### Addendum 1

Project File Architect's Project #: 20210121.50
Project Name: Hulbert EMS

- 1. Sheet CS Cover Sheet
  - 1.1 Removed exterior sheathing
- 2. Sheet A101 FLOOR PLAN AND ELEVATIONS
  - 2.1 Adjusted door schedule
  - 2.2 Added note for skirt board
- 3. Sheet S101 FOUNDATION PLAN AND FOUNDATION DETAILS
  - 3.1 Revised detail 10/S101

# ADDENDUM 01 – HULBERT MARSHAL/EMS BUILDING EXPANSION

**FOUNDATION PLAN AND FOUNDATION DETAILS**

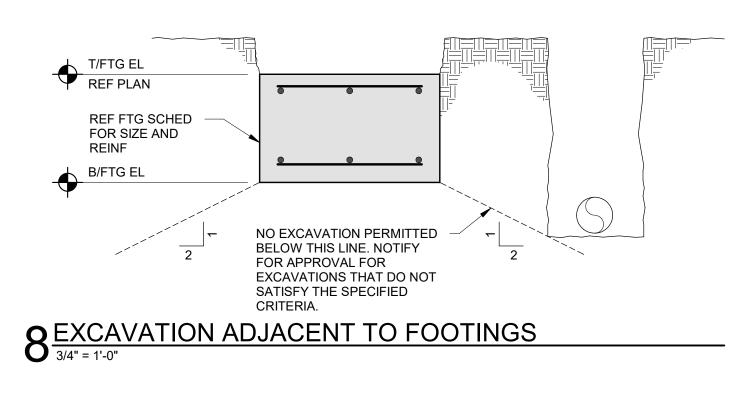
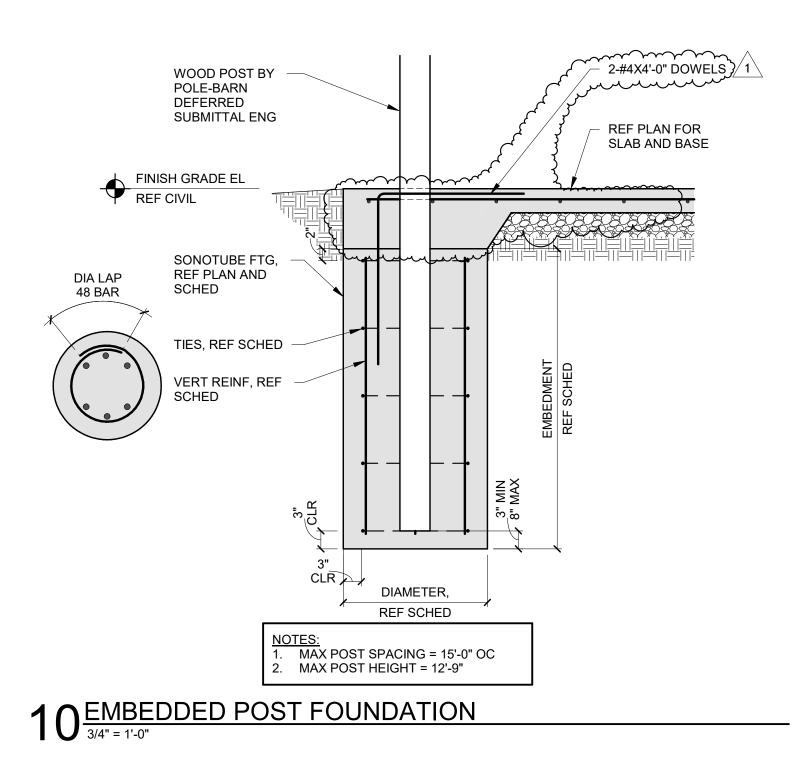
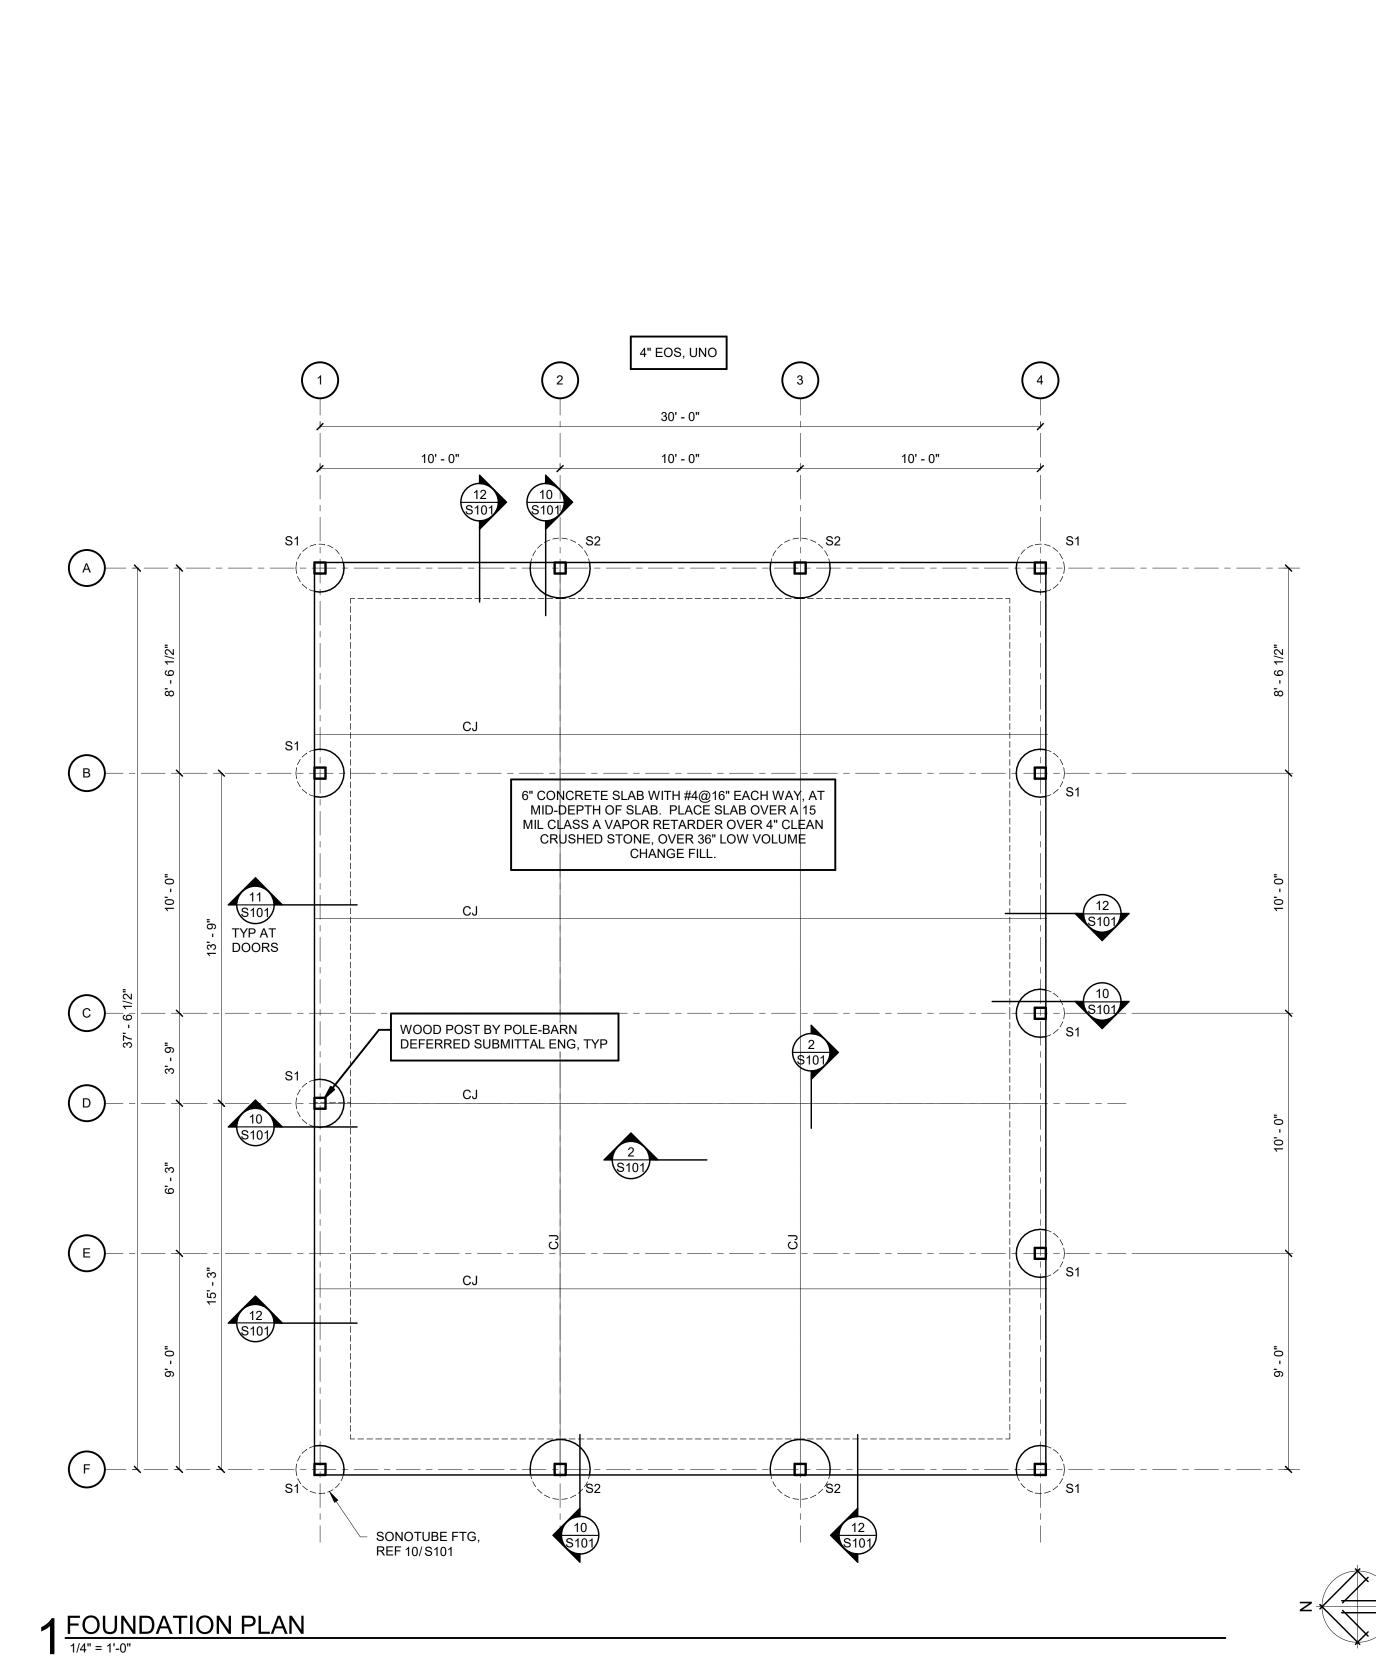
5. DETAIL 10 ON S- 101 SHOWS THE PEIR AT FINISH FLOOR ELEVATION; USALLY THESE ARE HELD DOWN TO ALLOW THE S.O.G TO ALIGN WITH THE OUTSIDE OF THE BUILDING. THIS WILL ALSO CONFLICT WITH THE PAVING.

6. DETAIL11 ON S-101 THE 90 DEGREE BAR DOESNT APPEAR TO TIE TO ANYTHING IN THE VERTICAL, PLEASE CONFIRM WHETHER THIS BAR SHOULD TIE INTO CIVIL PAVING REBAR.

ANSWER: See updated detail 10/S101.

ANSWER: This bar is for continuity between the slab on grade and turndown. This bar does not need to be connected to civil paving rebar.
